ISSUE: Certificate of Appropriateness for alterations

LOCATION: Old and Historic Alexandria District
329 North Washington Street

BAR#2023-00371 OHAD

Request for alterations at 329 N Washington Street
Applicant: Hershel Kleinberg and Lisa Cohen

Figure 2: Current proposed plan

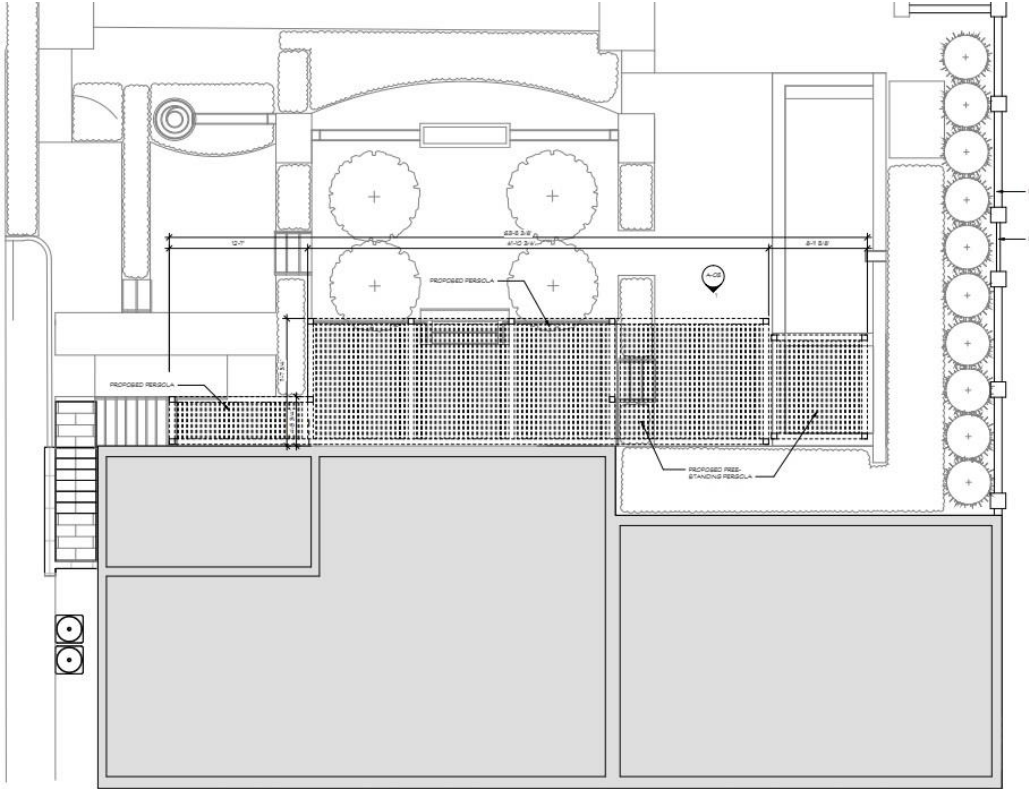
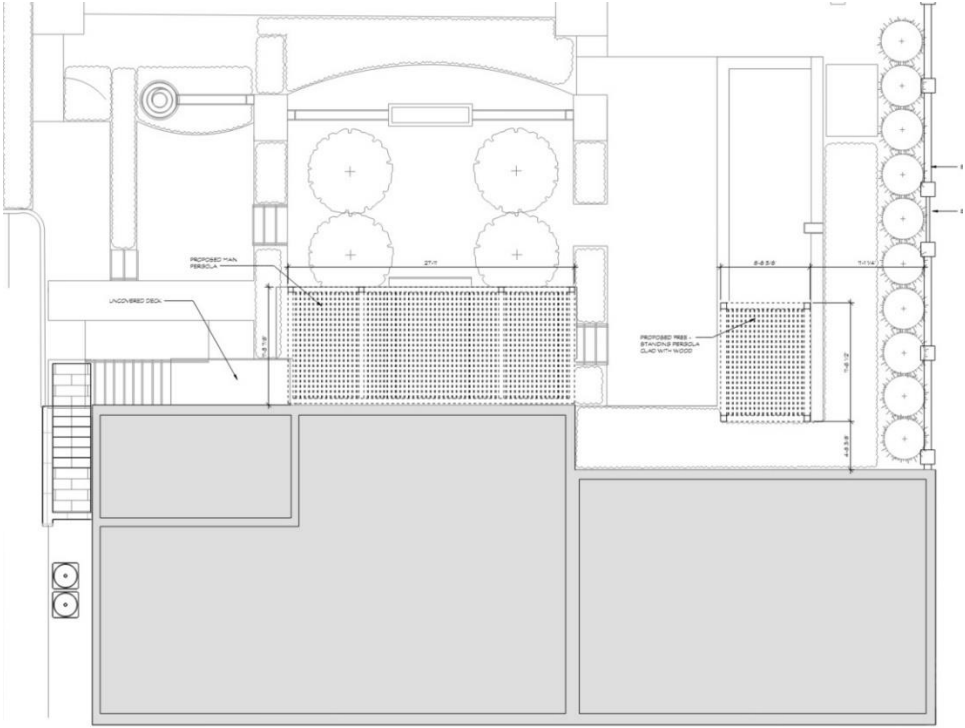
As the figures indicate, the current proposal greatly reduces the appearance and visibility of the original proposal. The new proposal also evenly spaces the columns on the main pergola attached to the modern addition, addressing the Board concern that the columns were haphazardly placed.
